UNITED STATES  
NUCLEAR REGULATORY COMMISSION  
REGION III  
799 ROOSEVELT ROAD  
GLEN ELLYN, ILLINOIS 60137

# MIDLAND PSAR INFO

MIDLAND PLANT UNITS 1 & 2

Responses to NRC Questions  
Midland 1&2

<b>CONSUMERS POWER COMPANY MIDLAND PLANT UNITS 1 &amp; 2 FINAL SAFETY ANALYSIS REPORT</b>
All Plant Area Boring Locations to Determine the Removal of Natural Sands with Relative Density Less than 75%
FSAR Figure 2.5-40A

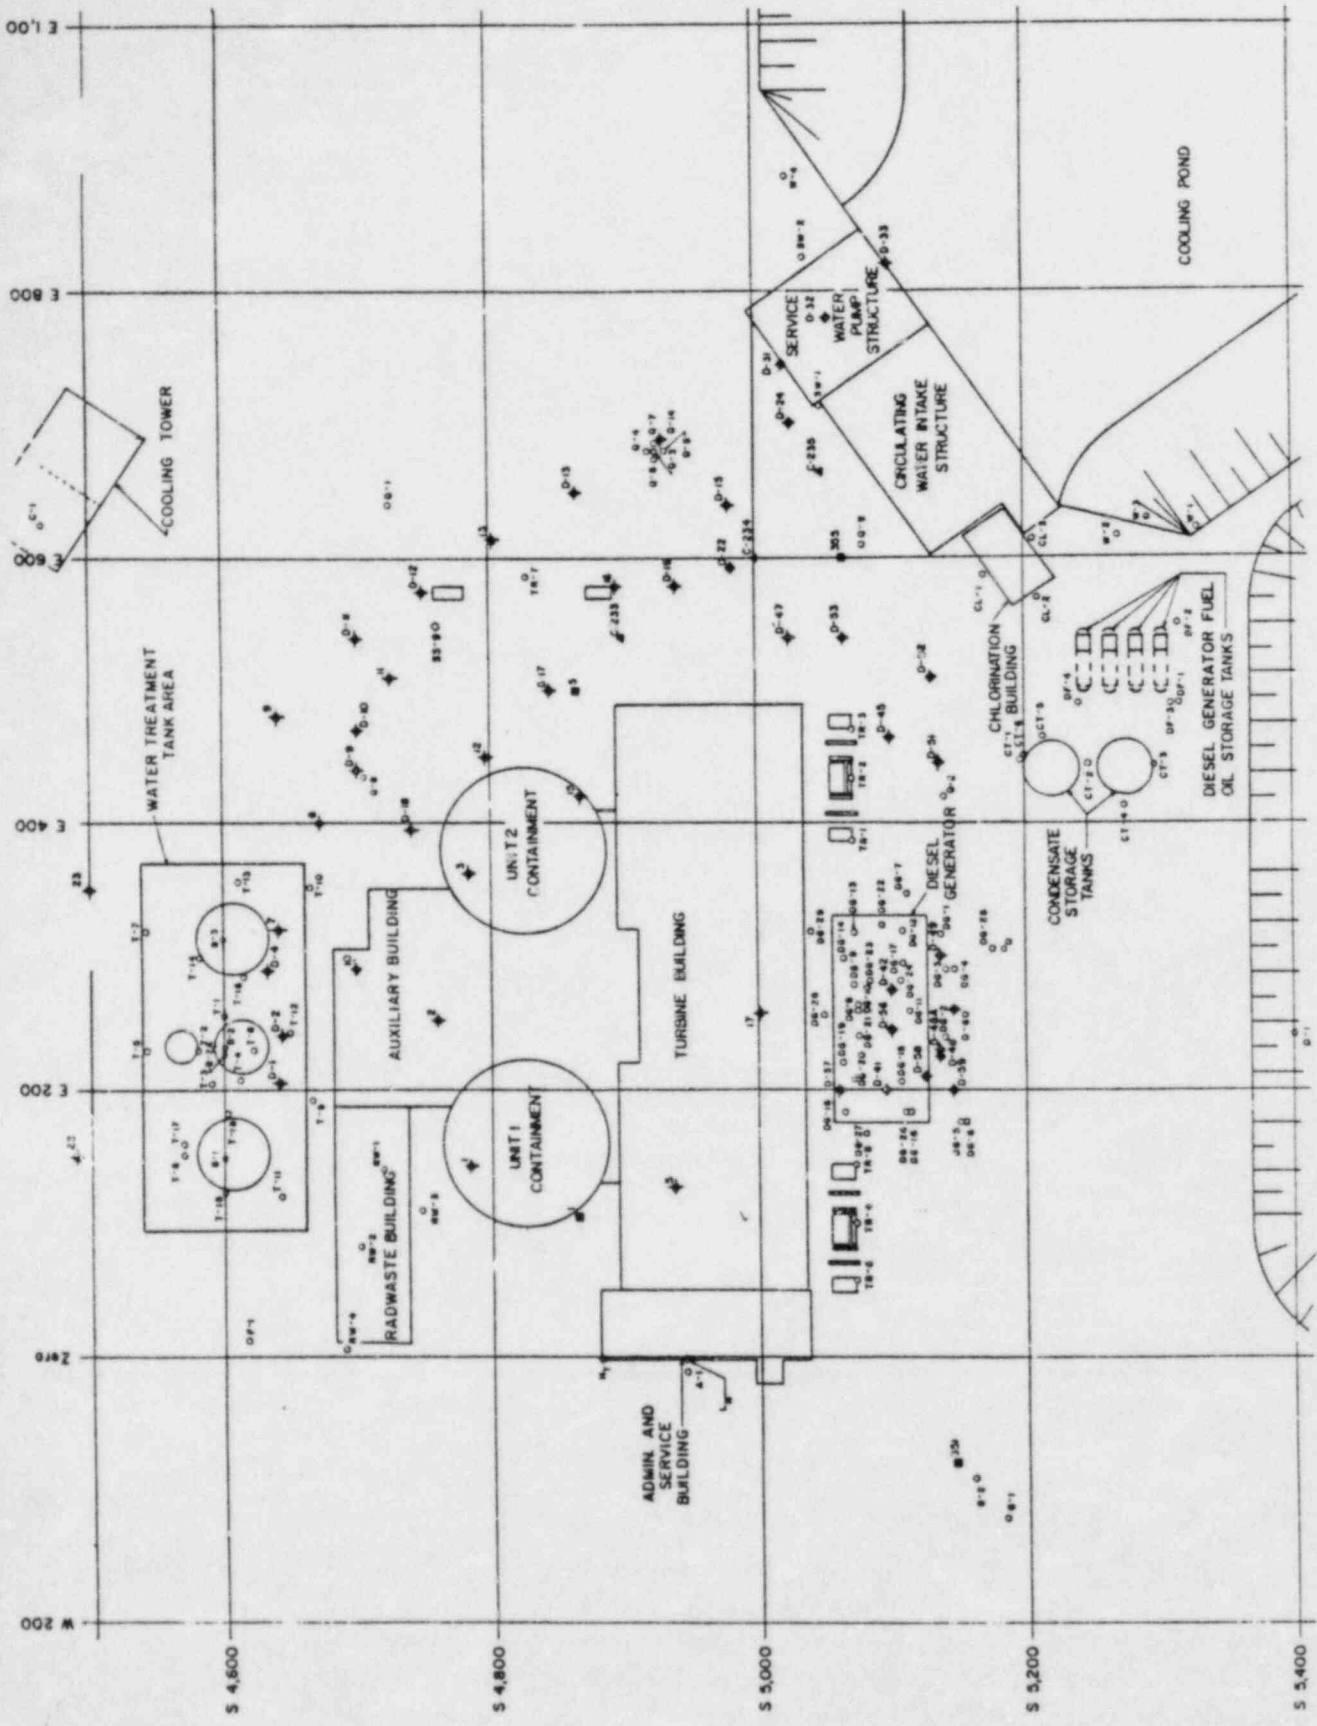
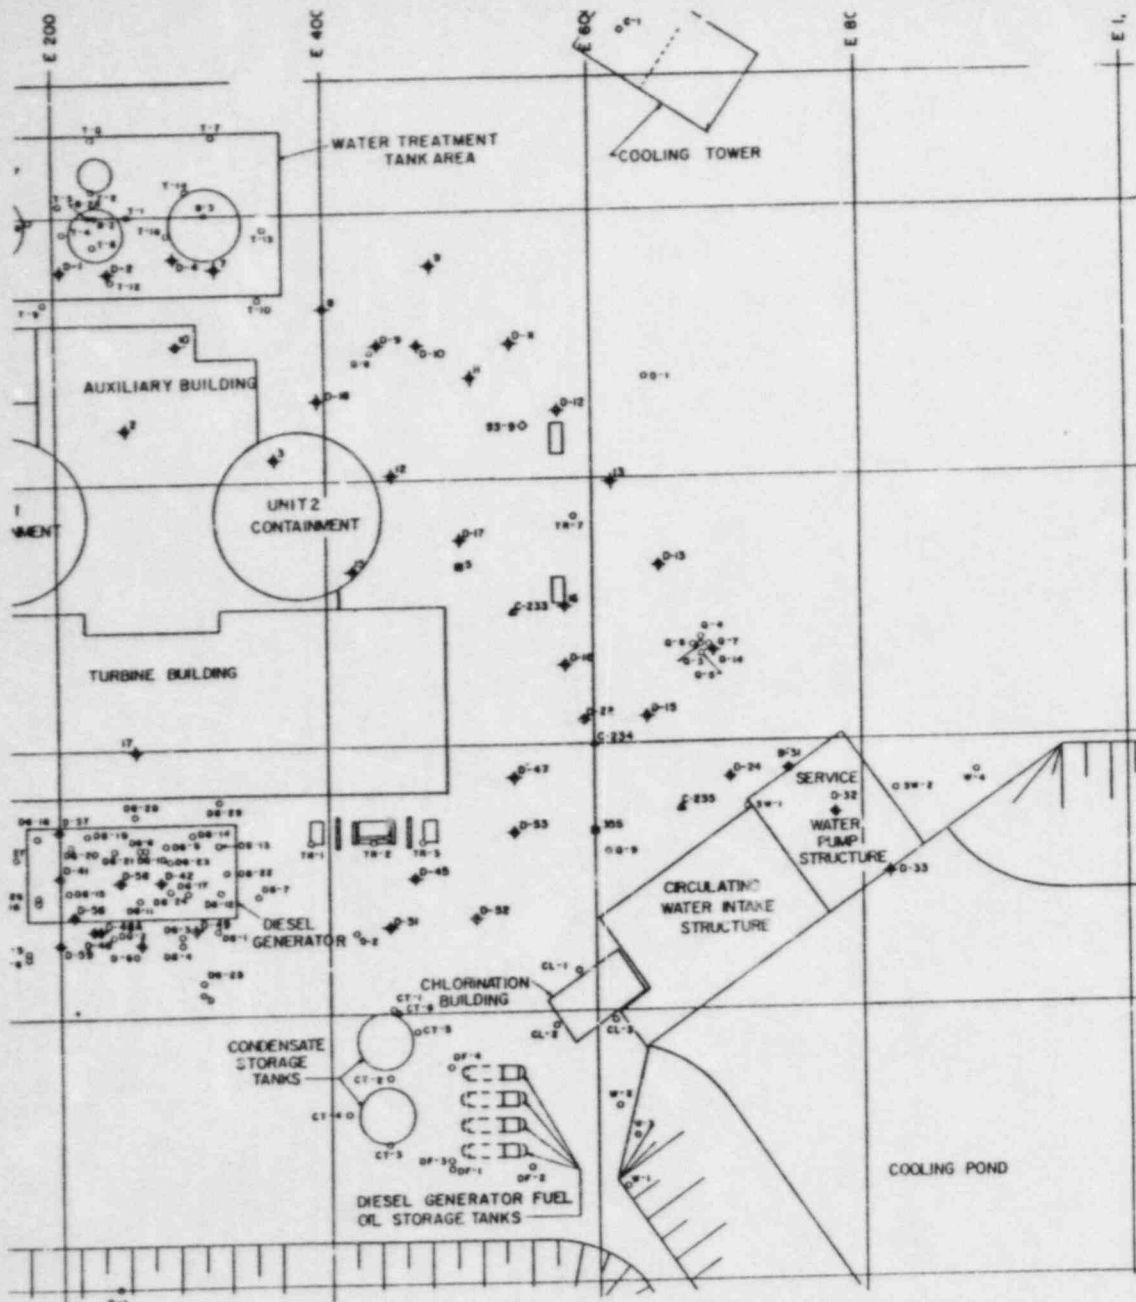
Question 1 and the resulting discussion on Page 8.00-1 included in Amendment Number 9 to your PSAR stated that all natural sands with relative densities less than 75% would be removed beneath all Class I structures and beneath non-Class 1 structures so sited that their failure could endanger the adjacent Class 1 structures. Discuss the methods employed in mapping and removing the sands having less than 75% relative density. Provide plan and sectional figures showing the areas where these materials were removed. Figure A9-2 of the PSAR which displays subsurface profiles of Class 1 piping should be updated to show removal of sands of less than 75% relative density and be presented in the FSAR. Figure 2.5-21 of the FSAR shows loose sands beneath the Class 1 tanks although they were to have been removed. Explain this inconsistency, and provide proper documentation of as-built conditions.

Numerous borings were made in August and September 1978 to determine that all natural sands with relative densities less than 75% have been removed beneath all Class I structures, piping, and non-Class I structures so that their failure could endanger the adjacent Class I structures. These boring locations are shown in Figure 2.5-40A. Up to a 35 foot thick compacted fill has been placed in the plant area to achieve a final plant grade elevation of 634 feet.

It is seen that the existing natural sands are dense with a relative density much greater than 75%. The sand lenses with the relatively low blowcounts encountered in the borings DG-7, DG-9, DG-28, and CT-1 are isolated and will not endanger the integrity of plant structures.
